UNITED STATES PATENT AND TRADEMARK OFFICE

APPLICATION NO.	FILING DATE	FIRST NAMED INVENTOR	ATTORNEY DOCKET NO.	CONFIRMATION NO.
10/612,370	07/03/2003	Kenneth Strannemalm	018798-172	3714

Office Action Summary	Application No. 10/612,370	Applicant(s) STRANNEMALM, KENNETH	
	Examiner Keshia Gibson	Art Unit 3761

Fig. A: Examiner's markup of Fisher's Fig. 1 to show hip and side sections.

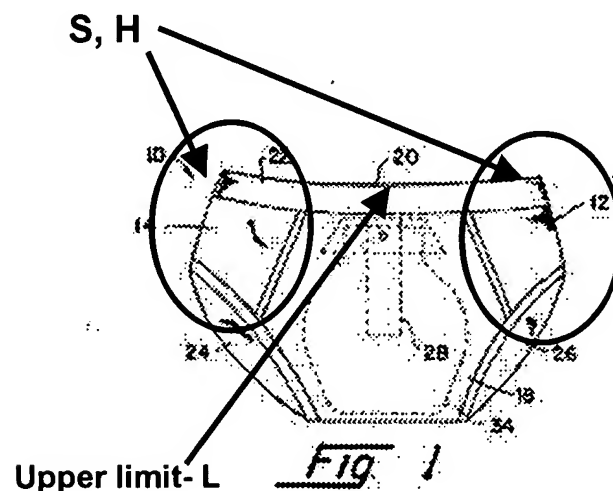
In regard to Claim 1, Fisher discloses a pants-shaped absorbent product 10 for males, comprising a front section 14, a rear section 16, a crotch section 18, side sections S to connect the front section 14 and the rear section 16 in the lateral direction, wherein the side sections S comprise hip sections H, an elastic waist region 12, 22, and an absorbent element 34, which covers the penis of the user (column 2, lines 58-column 3, line 10; Figs 1-2, Fig. A below).

(The front, rear, and crotch sections 14, 16, 18, are disclosed as being elastic (column 2, line 67- column 3, line 1); thus, the examiner considers the brief 12 (and more specifically, its upper half), which comprise each of these regions—along with waistband 22—to be the elastic waist region.) The product further comprises a liquid-tight outer layer 56 to cover the absorbent element 34 (54) at least on the side thereof facing away from the user when the product is worn; wherein the front section 14 has at least one elastic member 22. The elastic member 22 enables the front section 14 of the product to be pulled down during use, counter to the action of the elastic member, to a position in which the upper limit edge L of the front section 14 in the middle region of the front section 14 is situated below the penis of the user, at the same time as at least the hip sections H of the product are arranged to be held in place around the waist of the user (column 4, lines 20-54).

In regard to Claim 4, the elastic waist region 12, 22 completely surrounds the waist; therefore a section of it extends over the front section 14 between the hip sections H (Figs. 1-3 and Fig. A above).

and side sections S (Figs. 1-3 and Fig. A above). The elastic member 22 is shown to have a higher elastic stretchability than the rest 12 of the elastic waist region 12, 22.

In regard to Claim 14, the absorbent element 34 extends in the longitudinal direction over the whole of the crotch section 18 and slightly up over the front section 14 in the direction of the upper limit edge L during use (Figs. 1-3, 6 and Fig. A above; column 2, lines 3-4; column 3, lines 28-34).
